**PROPOSED MODIFICATIONS TO PLANNING COMMISSION  
RECOMMENDATION**

**OTPA S02-II-V2**

**Revised 12/3/04**

**Linda Q. Smyth, Providence District Supervisor  
Decision Only – December 6, 2004**

Figure 7

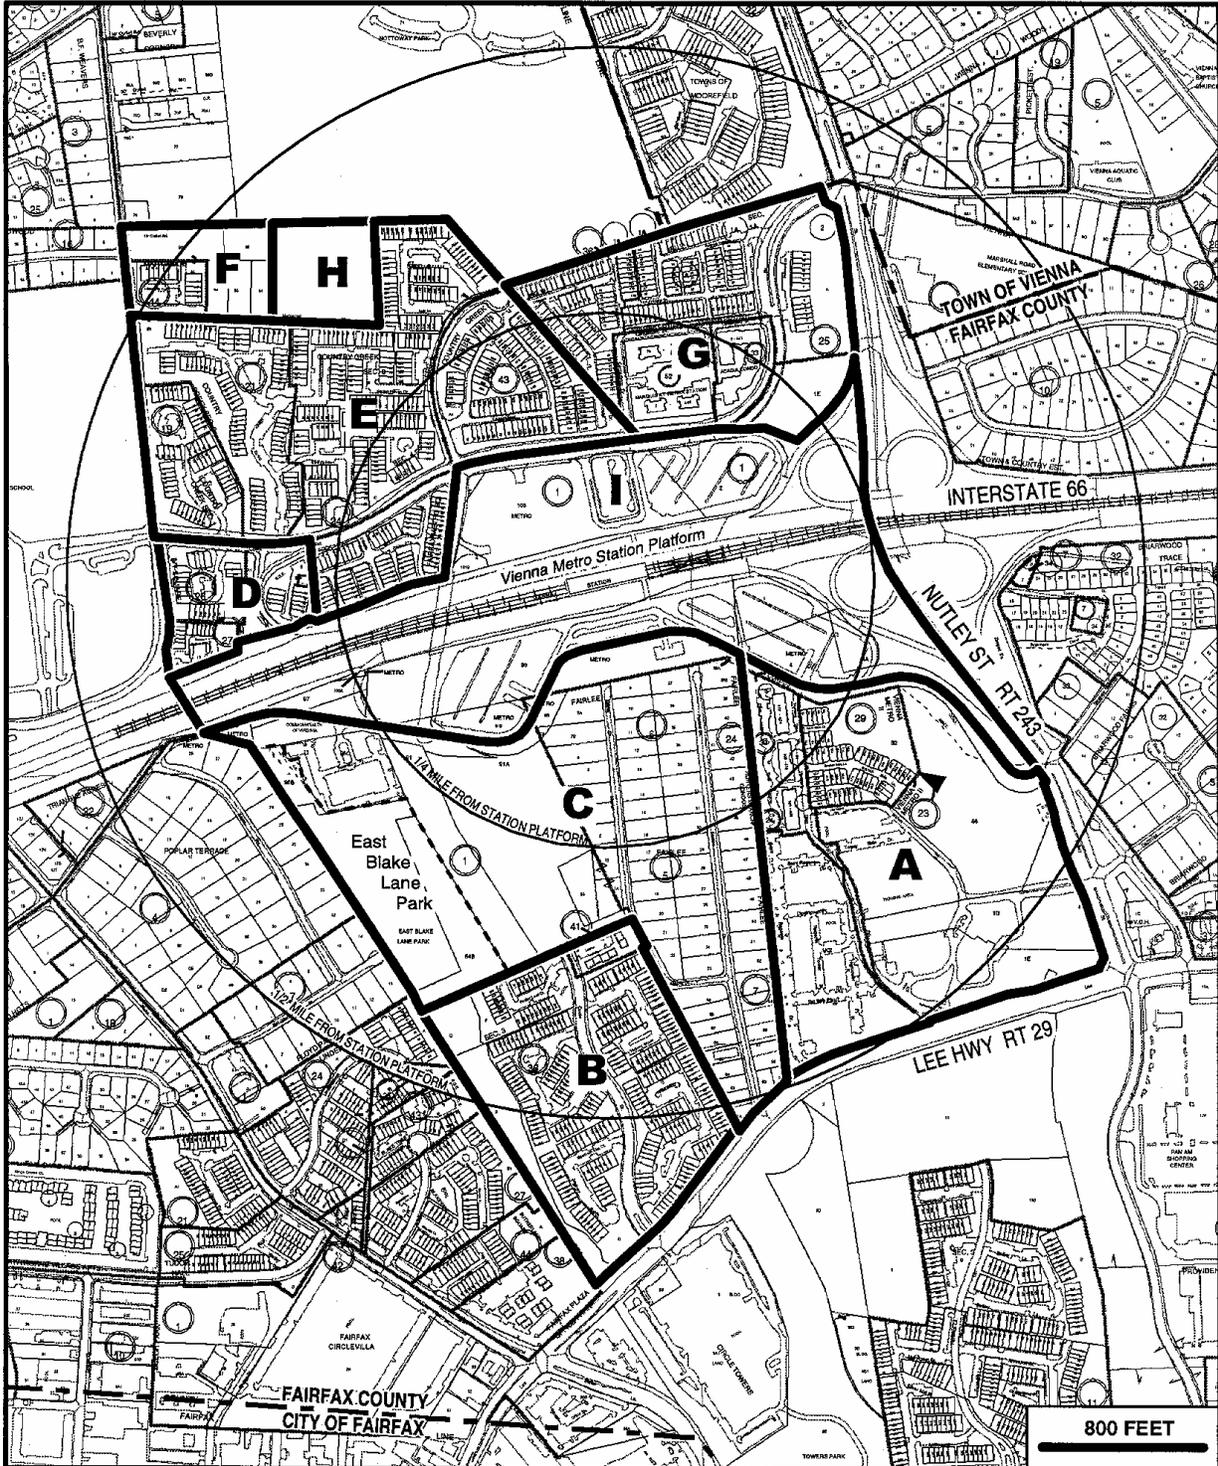
**Note:** As part of this amendment a new Land Unit C is created that combines old Land Units C and I with the WMATA property that is south of Saintsbury Drive. The WMATA Vienna Metro Station property that is bounded by Vaden Drive, Saintsbury Drive, Nutley Street and Virginia Center Boulevard will become the new Land Unit I. Figure 7 is a map showing the proposed new land unit designations and is provided on the following page.

1. Combine Land Units C and I and the WMATA property south of Saintsbury Drive to form a new Land Unit C;
2. Designate the Metro Station area, now labeled “Vienna Station,” as a new Land Unit I; and
3. Adjust the eastern boundary of the Vienna Transit Station Area to follow the current alignment of Nutley Street.

**TRANSPORTATION RECOMMENDATIONS VIENNA TRANSIT STATION AREA V1, V5 COMMUNITY PLANNING SECTORS** **FIGURE 8**

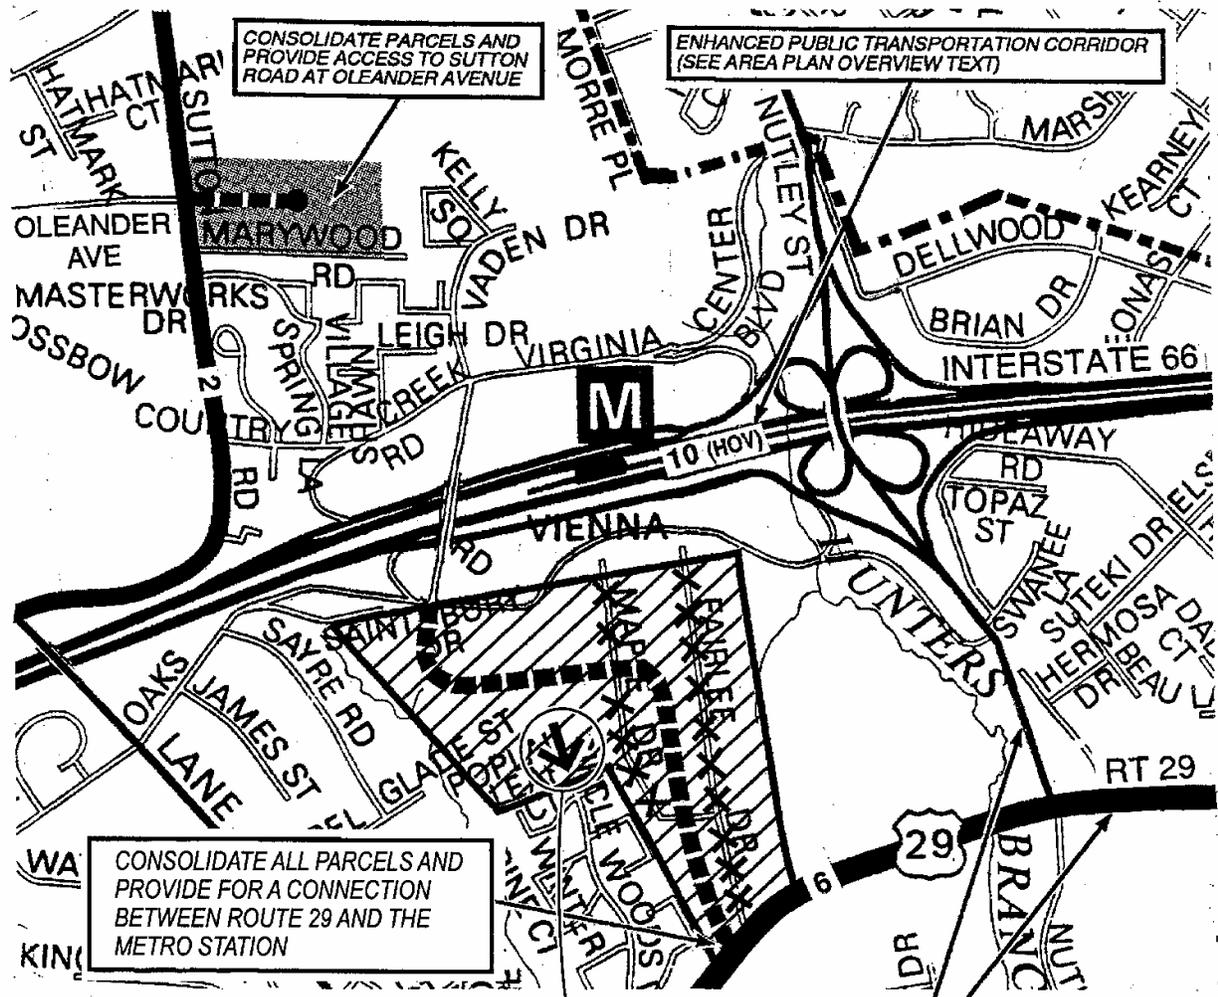
Delete arrow

1. Change the note to read, “Provide for a four-lane connection (Vaden Drive Extended) between Route 29 and the Metro Station. See Plan text under Land Unit C.”
2. Add shaded area for new Land Unit C and a note to read, “See Land Unit C text for additional transportation recommendations.”
3. Remove arrow that indicates possible access to Circle Woods Drive.
